**Item 6.****Development Application: 136 Hay Street, Haymarket - D/2023/887****File No.: D/2023/887****Summary****Date of Submission:** 29 September 2023**Applicant:** Terri Slater**Architect/Designer:** BVN**Developer:** The Trustee for Platinum Unit Trust**Owner:** Platinum Hotel Holding Pty Ltd**Planning Consultant:** Architectus**Cost of Works:** \$104,334,709.00**Zoning:** SP5 - Metropolitan Centre

**Proposal Summary:** Approval is sought for the construction of a 16 storey mixed use building over 4 basement levels, comprising retail uses, tourist and visitor accommodation, and a supermarket.

**Figure 32:** Proposed Stage 2 detailed design

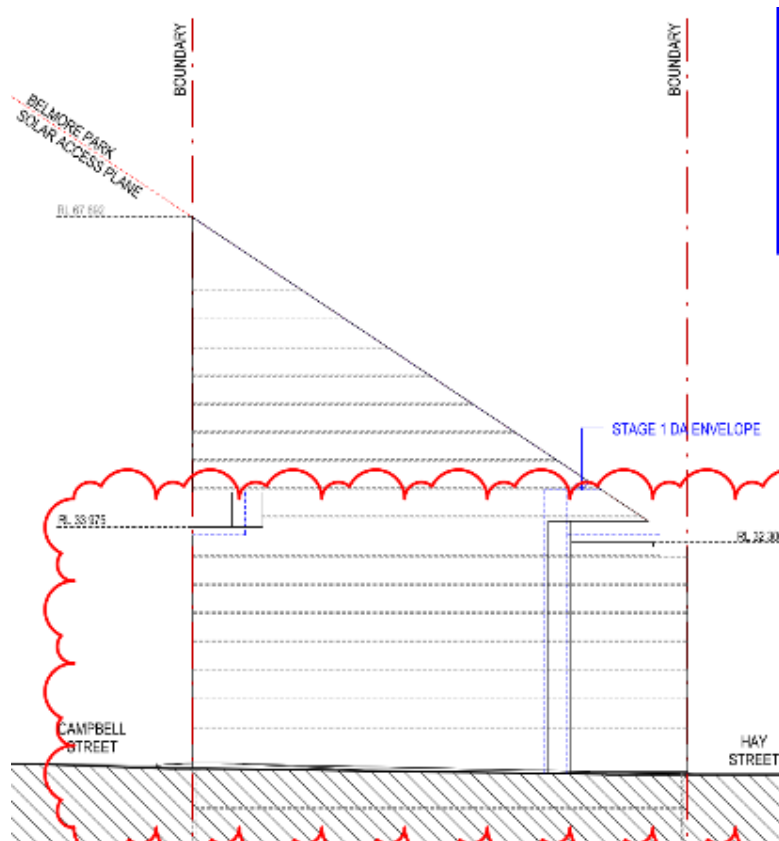
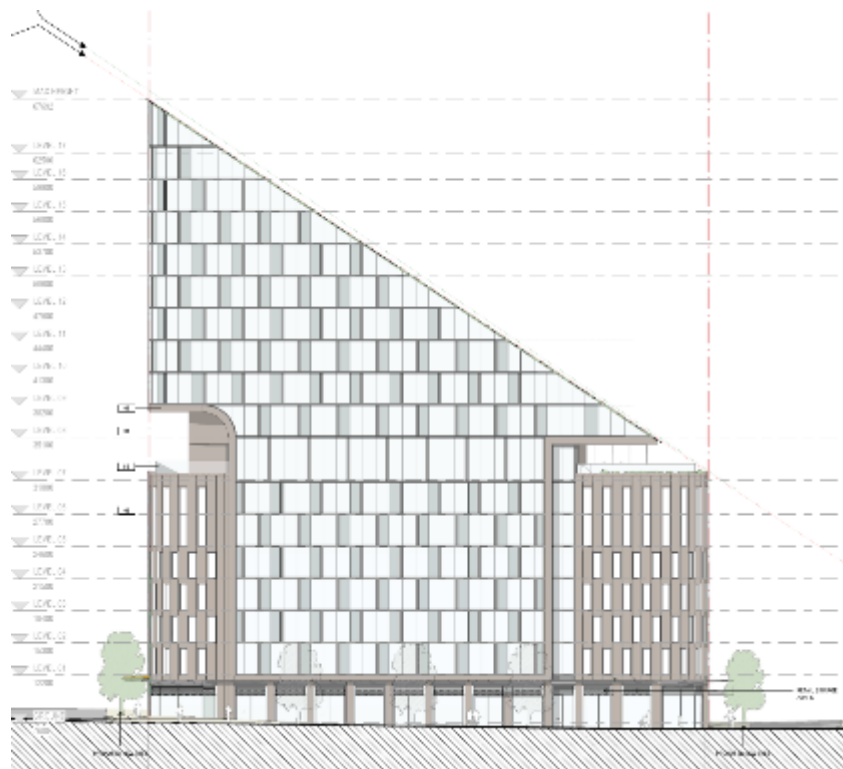
57. In addition to complying with the conditions of the Stage 1 consent, the City's modelling team has confirmed that the submitted 3D digital model is generally consistent with the approved building envelope, with the exception of minor facade elements (awnings, architectural detailing), and the glass enclosed portion of the level 7 terrace.

58. As demonstrated above, the proposed development is in accordance with CI 4.24(2) of the Environmental Planning and Assessment Act 1979, in that it is not *"inconsistent with the consent for the concept proposals for the development of the site"*.

**Figure 33:** Proposed unenclosed nominated bulky waste area for the supermarket

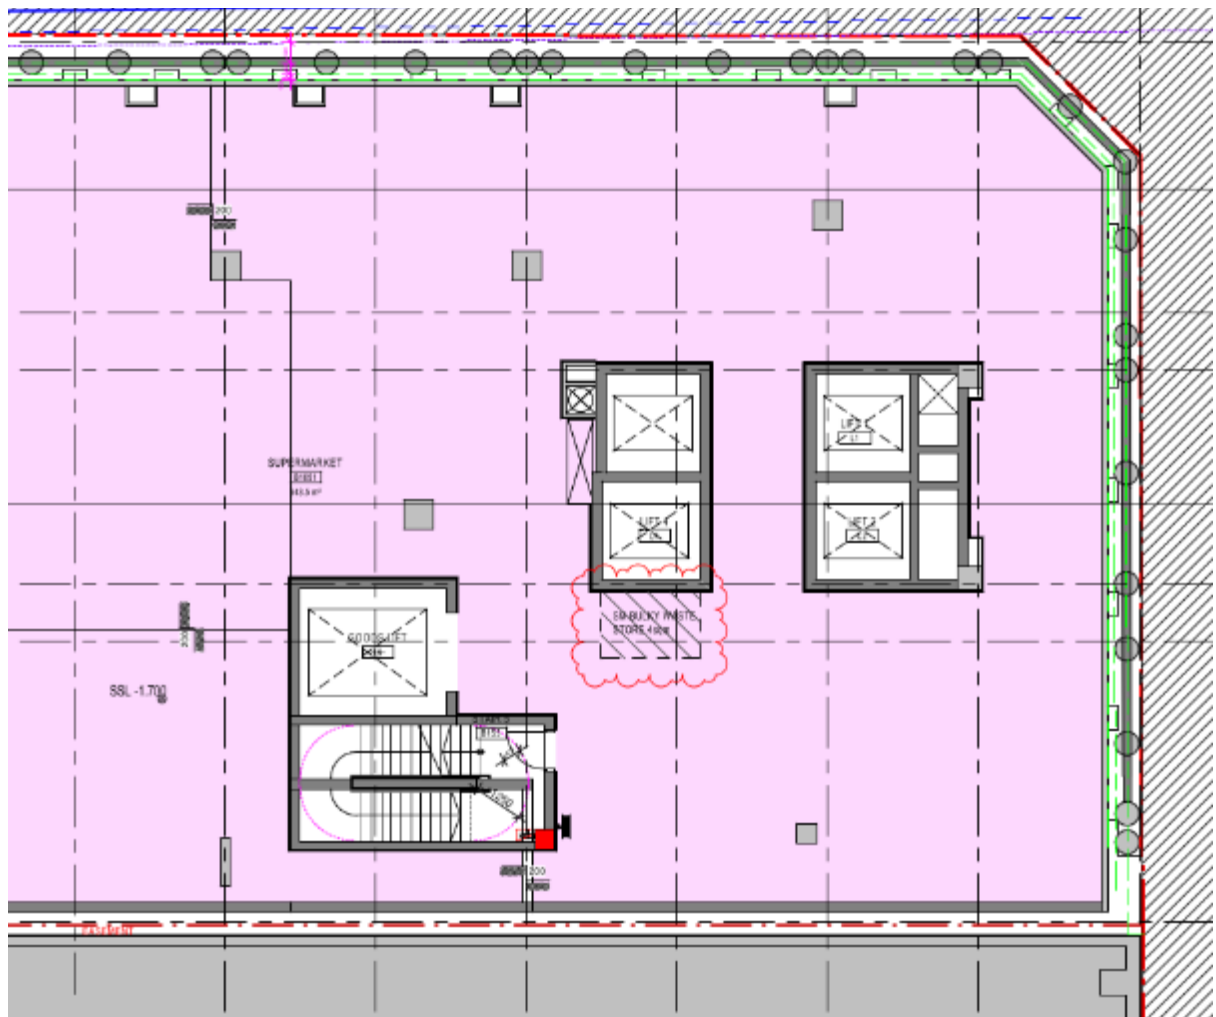
86. Amended architectural plans were subsequently submitted which depict waste storage areas and bins on the plans, as well as an amended waste management plan, to provide additional justification for the proposal not meeting the requirements of Council's current waste management policy. It is noted that information was not provided directly from Coles to confirm the standard waste management practices of Coles supermarkets.

87. The waste generation estimates in the amended waste management plan have been revised to closer align with the City's recommendations and estimates. A greater frequency of waste collection is proposed to accommodate the shortfall in waste bins and storage areas. While the City's Waste & Cleansing team generally accept the revised spatial allocation of waste storage areas and collection frequency, the unenclosed nominated bulky waste storage area for the supermarket (4 sqm) on basement level 1 (shown below) is not considered sufficient. Council's Waste Management Officer recommends that an enclosed (or caged) area be provided for the supermarket bulky waste that is large enough to store two days generation of waste.

88. In addition, Council's Waste Management Officer also note that the hotel and retail waste storage area on Basement Level 2 (39 sqm and 22 sqm) have engaged the use of a cardboard baler to reduce the waste storage space needed, and concern is raised regarding the practicality of transporting the baled cardboard to Ground Floor Level for collection given that a forklift is generally required to transport baled cardboard.

**Figure 34:** Proposed ground floor plan showing the path of travel in red for the waste bins to reach the goods lift from the retail tenancies

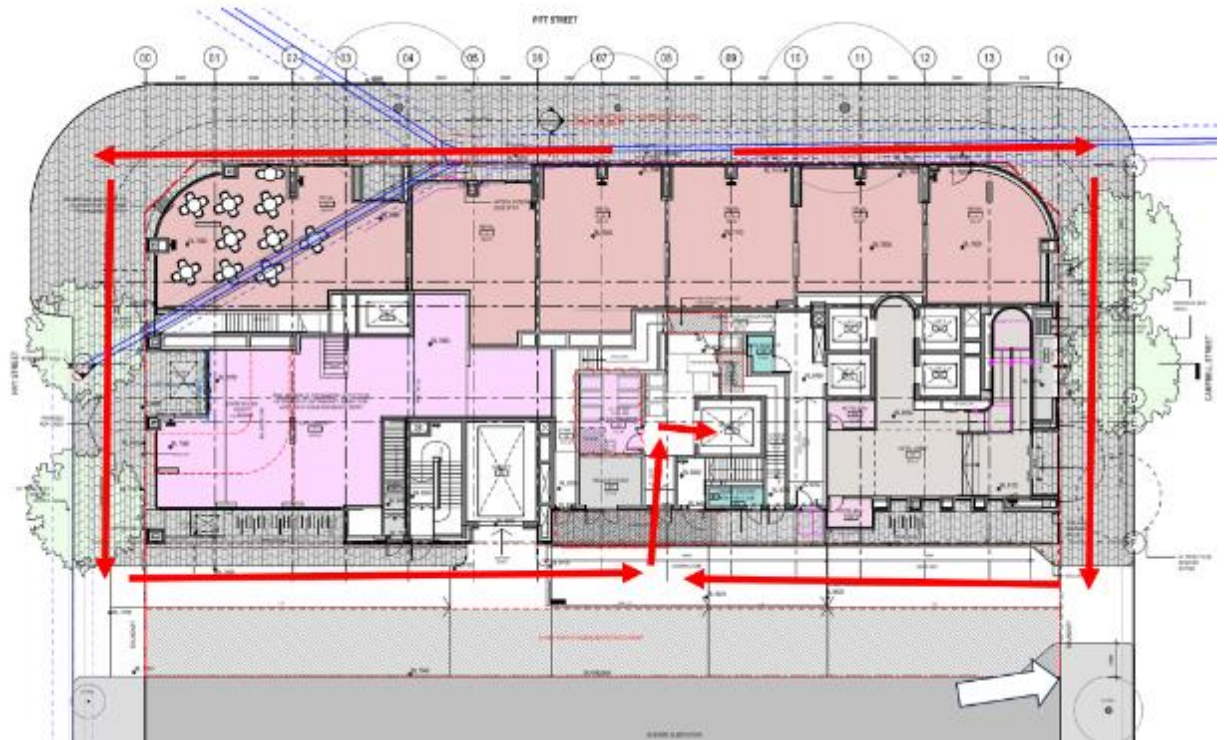
89. The applicant justification for the waste arrangements for the retail tenancies is that it was previously approved under D/2017/727, this arrangement is common in other developments within the City, and that providing a BOH (back of house) corridor for the retail tenancies would result in a significant reduction in the floor area of the retail tenancies, such that they would become unviable.

90. The proposed waste arrangement for the retail tenancies is not supported by Council's Waste & Cleansing team, noting that bins for the retail tenancies will need to be transported between 70-100m around the outside of the building to reach the waste storage area and goods lift, as demonstrated in the below figure.

91. The ground floor plan indicates that providing BOH access to the retail tenancies could potentially be achieved with minimal reconfiguration of the ground floor layout by providing internal openings at the rear of the two middle retail tenancies, and extending the proposed service corridor to access the remaining retail tenancies as demonstrated in the below figure.

**Figure 38:** West elevation showing 15m street frontage height by broken line

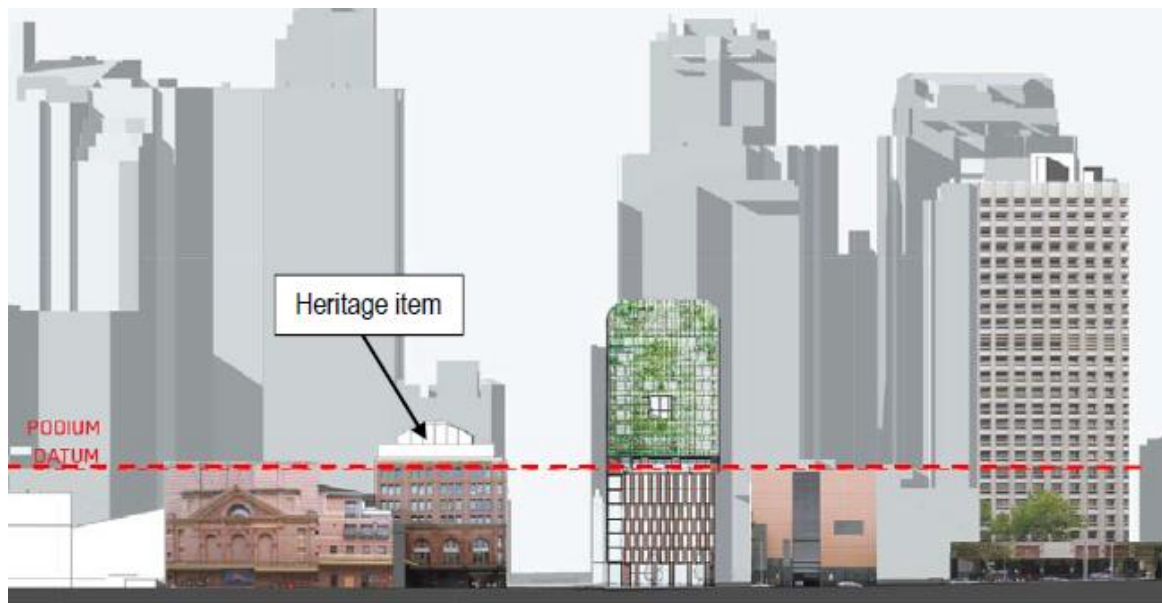
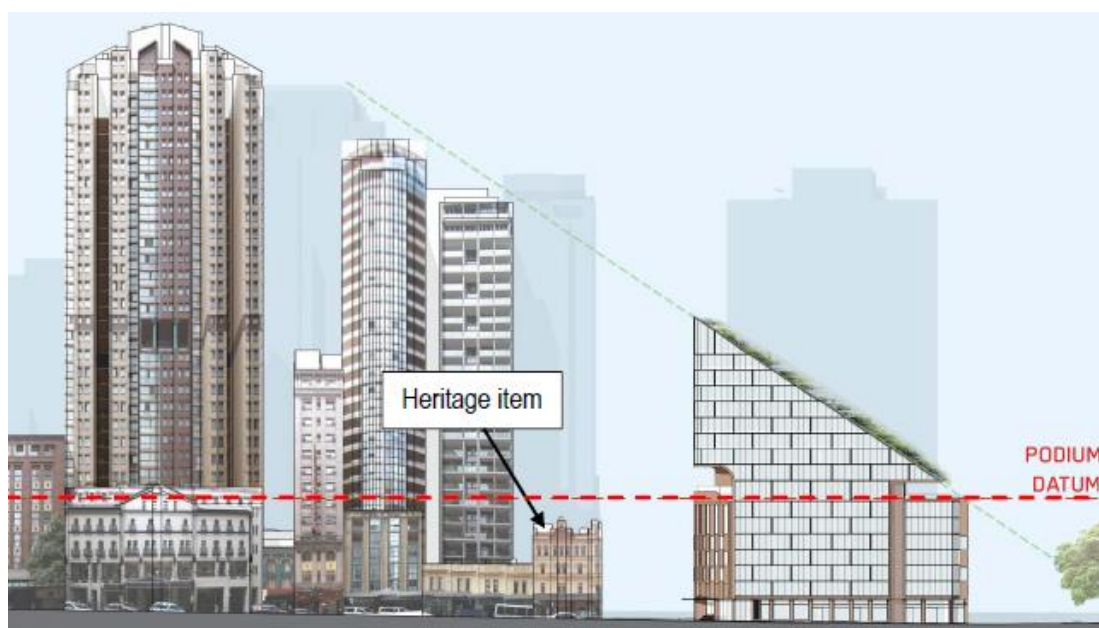
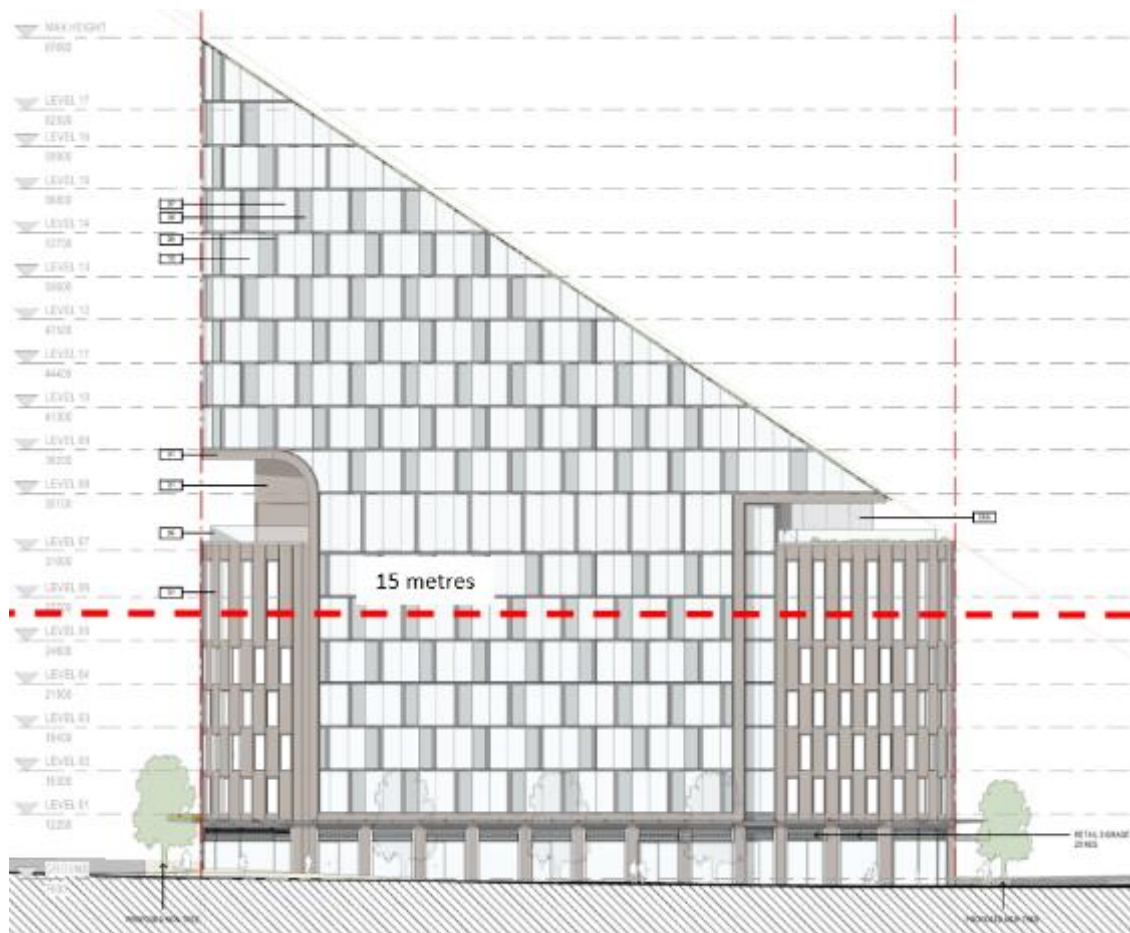
93. Section 5.1.1 of SDCP 2012 requires a street frontage height for new buildings located within the Railway Square/ Central Station Special Character Area of no greater than 15 metres above ground level. The minimum setback required above the 15 metres street frontage height is 8 metres to Hay St, Campbell St and Pitt St.
94. The proposed development provides a street wall height that gradually increases from 21 metres at the southern end of the site to 60 metres at the northern end. The only setbacks occur at Level 7, comprising outdoor terraces with external walls/ glass line setback approximately 4 metres from the northern boundary and 6 metres from the southern boundary.

95. The non-compliance with the street frontage height and setback requirements under DCP 2012 are considered acceptable as the scale of the building has been minimised through massing and material treatment. In addition to the tapered height, the building is articulated as a masonry base intersected by a glazed volume, with a vertical slot extending from the ground floor to Level 8 at the southern end of the western façade (Pitt Street), and horizontal insets at Level 7. As such the massing is modulated in a way that minimises the building's bulk by breaking it up into discreet components.
96. The masonry base is consistent with and complements the street frontage heights of surrounding heritage items and is proportionately consistent with the brickwork to window opening ratio, of the Manning Building at 451 Pitt Street. Refer to below figures.

**Figure 39:** Level 7 southern terrace with recommended setback of glass line in red

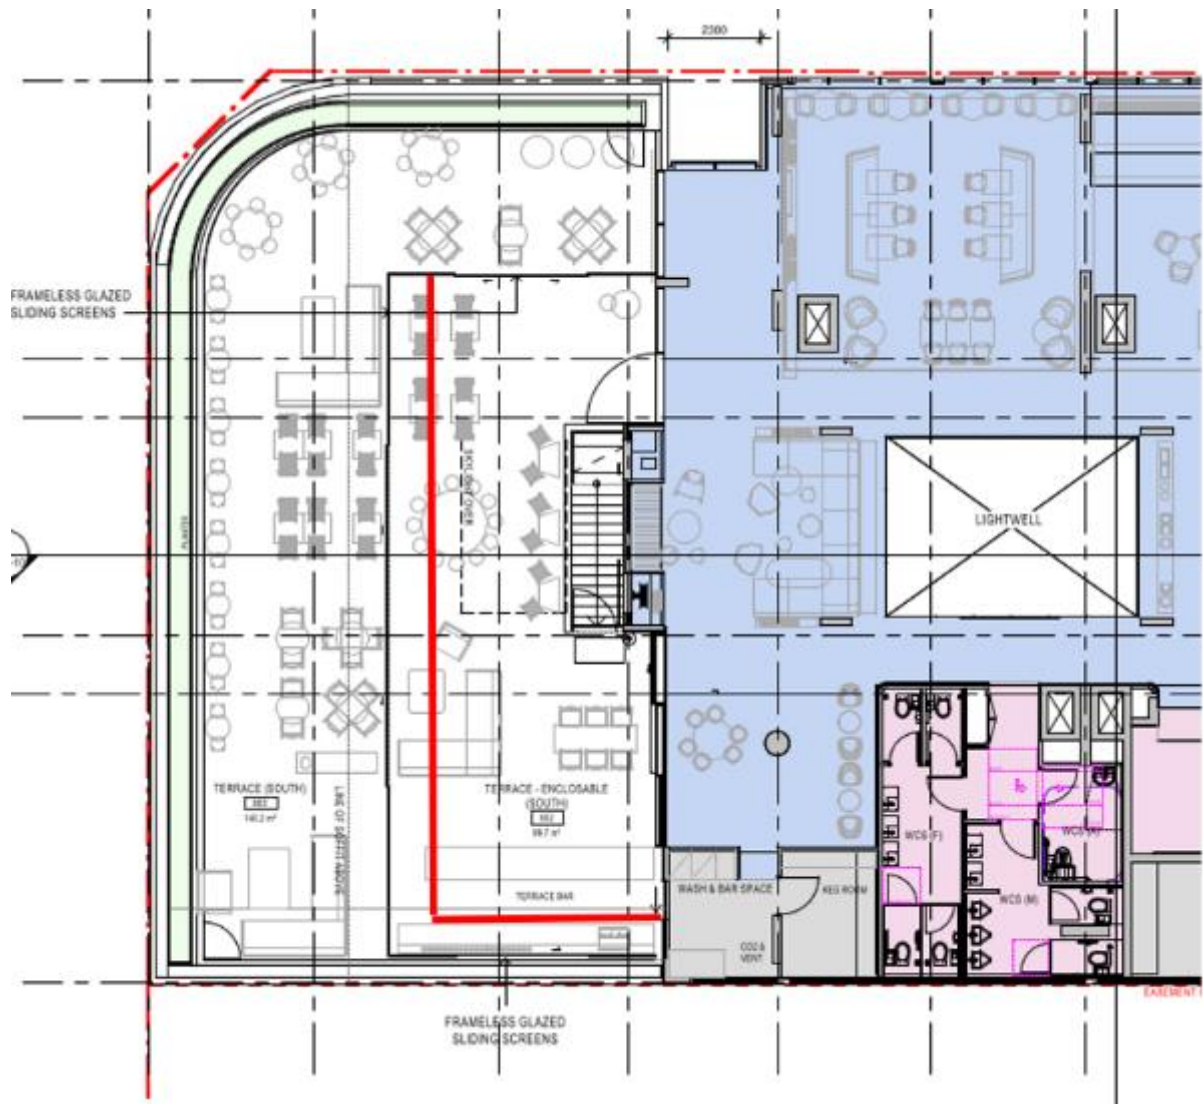
97. As discussed elsewhere in this report, the proposed detailed design is consistent with the approved Stage 1 Concept building envelope, and additionally the form of the proposal is constrained by the various easements and covenants on the subject site, as well as the Belmore Park Sun Access plane. Therefore, the non-compliance with the DCP street frontage height and setback controls is considered acceptable within the context of the subject site.
98. An increased setback of 1m of the glazing line of the level 7 (podium level) southern enclosed terrace from the southern and eastern boundaries is recommended to reduce the bulk which diminishes the reading of the articulated rebate, as shown in the below figure.

99. A condition of consent is recommended to increase the southern and eastern setbacks to the glass line of the level 7 southern enclosed terrace.
